STAFF REPORT AMENDED 11-24-82  
CITY PLANNING COMMISSION

- APPLICATION:
1. Environmental Determination
  2. Tentative Map (P82-207)
  3. P.U.D. Schematic Plan Amendment to reduce the square footage of buildings designated in the P.U.D. by 76,000± sq. ft.; to relocate buildings; and reorient interior circulation
  4. Special Permit for P.U.D. development to allow the development of a 55,000 sq. ft. warehouse and a 60,000 sq. ft. warehouse on 2 separate parcels

PROPOSAL: The applicant is requesting the necessary entitlements to divide 33± acres into three parcels and develop 8.4± acres with two warehousing facilities in the Hansen Industrial Park P.U.D.

APPLC. NO. P82-207

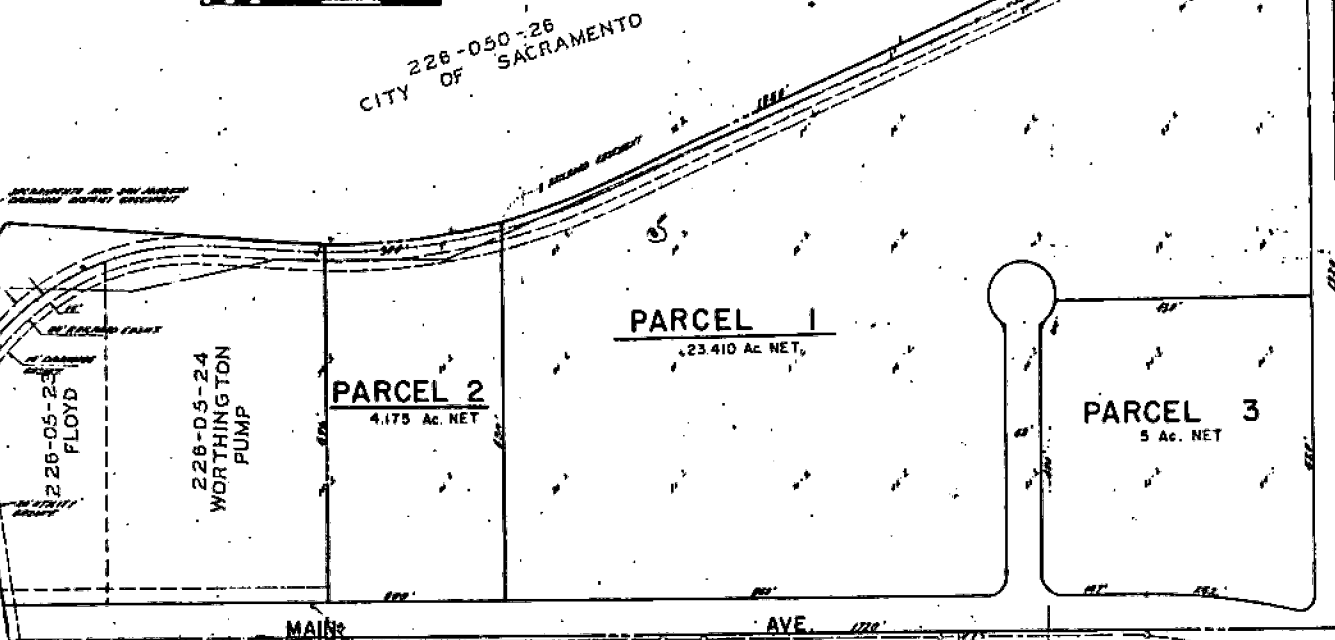
- a. Provide standard subdivision improvements pursuant to Section 40.811 of the City Code.
- b. Prepare a sewer and drainage study for the review and approval of the City Engineer. Sewer and drainage shall extend westerly to Western Pacific RR as required in previous agreement. Sewer and drain system shall require over sizing and off-site extension (sewer must extend east to Regional Interceptor near Rio Linda Boulevard).

- c. Must initiate annexation proceedings to annex to Regional Sanitation District. Final map cannot be filed until facilities are in operation.
- d. Additional pump and appurtenances must be installed at existing pump station east of Kelton Avenue.

- e. Right-of-way study required for Main Avenue, must dedicate sufficient right-of-way for a 60 foot halfsection.
- f. Dedicate sufficient right-of-way for slope easement at north end of Kelton Way.

- g. *Improve west side of Kelton Way up to and including access point*  
~~Dedicate right-of-way/Kelton Way~~ to a 45 foot halfsection. (amended by CPC)

- h. Right-of-way study and off-site pavement taper required for the north-east corner of Kelton Avenue and Main Avenue.
- i. A truck entrance shall be provided from Kelton Avenue to the northern portion of the site when Parcel 1 is developed. Location of the access shall be approved by the Planning Director.

- j. Reciprocal access easements shall be provided between the Nabisco site and the remainder of the P.U.D. (Parcels 1 and 2) ~~at the front of the property~~.  
*only in the front portion of the property (amended by CPC).*

GM SITE PLAN

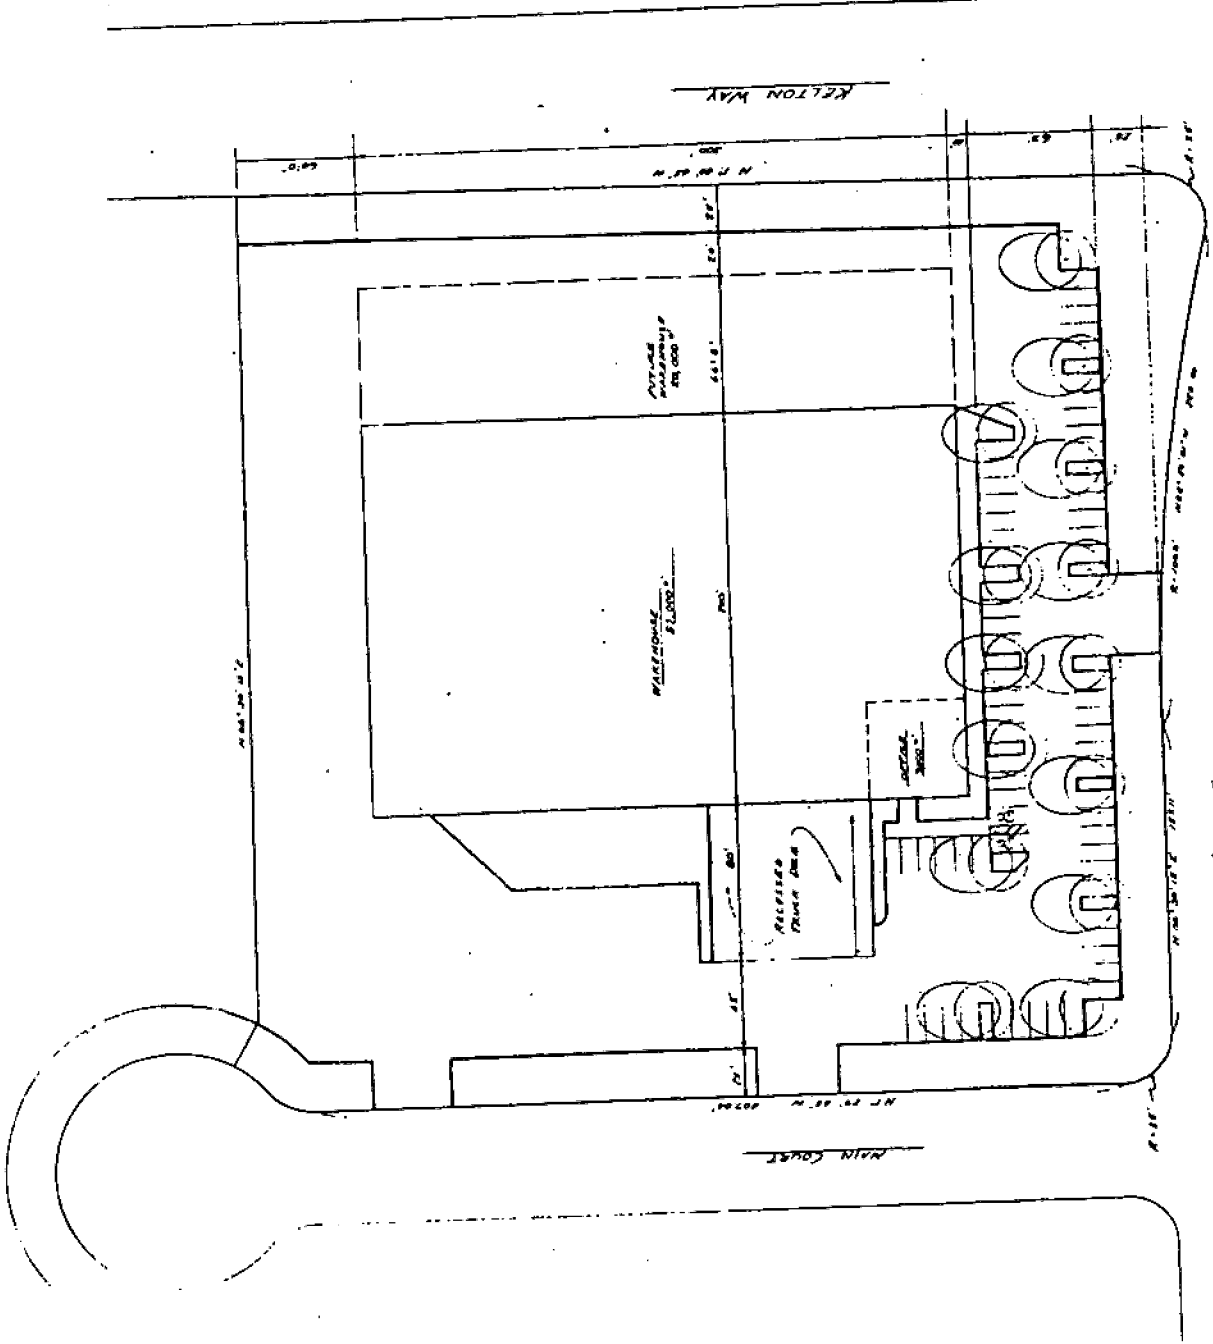
7. The site plan for the GM building indicates an excess of unused land on the northern and eastern portion of the site. Staff requests this area be landscaped.

8. Both structures are proposed to be concrete tilt-up parcels, 24 feet in height. Earth tones are compatible with the P.U.D. guidelines and staff believes these buildings meet the intent of these guidelines. Staff suggests a wing wall be added to the GM building to buffer the loading docks from view on Main Avenue (see exhibit A-1).

1. comply with P.U.D. guidelines (see exhibit A-2);
  2. exhibit a common theme;
  3. demonstrate shading of 50% of surfaced parking area;
  4. incorporate an additional 30 feet of planting on the north and east side of the GM building. This additional area can be planted with grass or similar ground cover.

- d. The loading area of the GM site (NW corner of Main Avenue and Kelton Way) shall be screened with a wing wall as shown on exhibit A-1.
